Gatwick Airport Northern Runway Project

The Applicant's Response to the Examining Authority's
Written Questions – Air Quality

Application Document Ref: 10.16

Figure 1 Location of the Hazelwick AQMA and extension

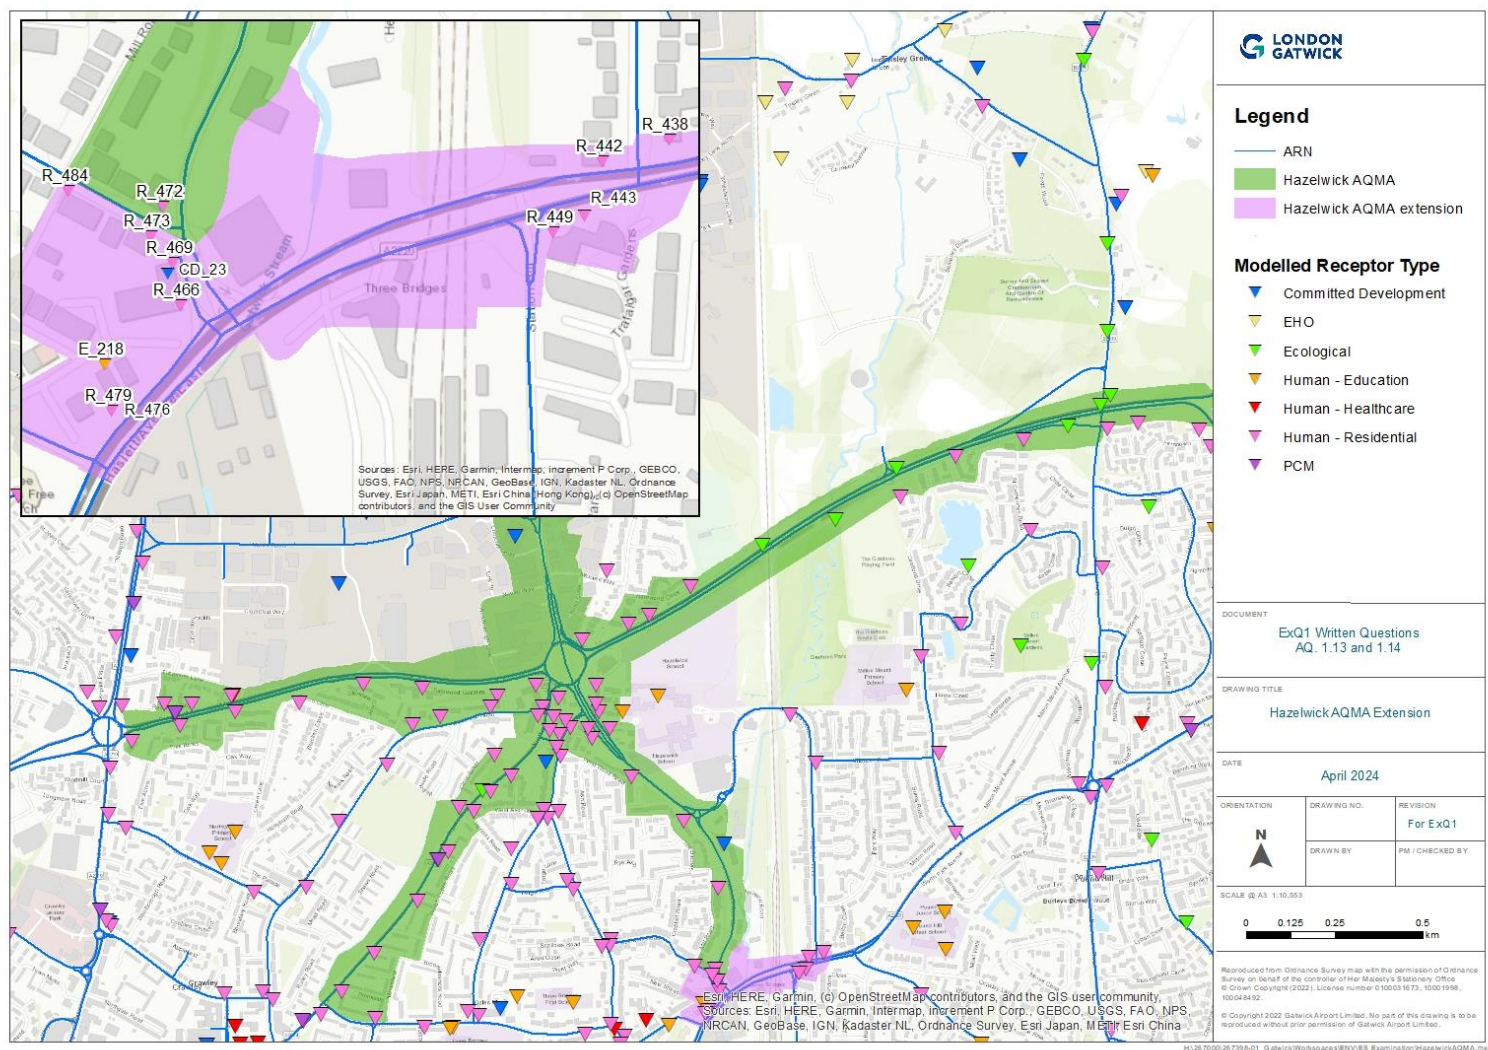
AQ.1.13	The Applicant	<p>Effects on the Hazelwick AQMA</p> <p>ES Chapter 13, paragraph 13.7.2 [APP-038] identifies Horley AQMA and Hazelwick AQMA as the only two AQMAs located within the 10km x 11km study area. Hazelwick extension is stated to be the area where the Three Bridges are, which is an additional area onto the southeastern arm of the current Hazelwick AQMA.</p> <p>These two AQMAs are located in the Air Quality Figures Part 1 on Figure 13.1.11 [APP-066] however, it is not clear whether the extension is included in this Figure.</p> <p>Can the Applicant confirm the location and extent of the Hazelwick AQMA extension in relation to the Proposed Development either in the existing documentation or provide an appropriate Figure?</p> <hr/> <p>The Hazelwick Air Quality Management Area (AQMA) and extension is located approximately 3km south of the Order Limits. The original AQMA was declared on 09/07/2015 for exceedances of the annual mean NO₂ air quality standard. The extension of Hazelwick AQMA was declared on 11/03/2022. Figure 1, below, has been provided below showing the location of the original AQMA (in green) and the extension (in purple). The assessment in ES Chapter 13: Air Quality [APP-038] included the extension area.</p>
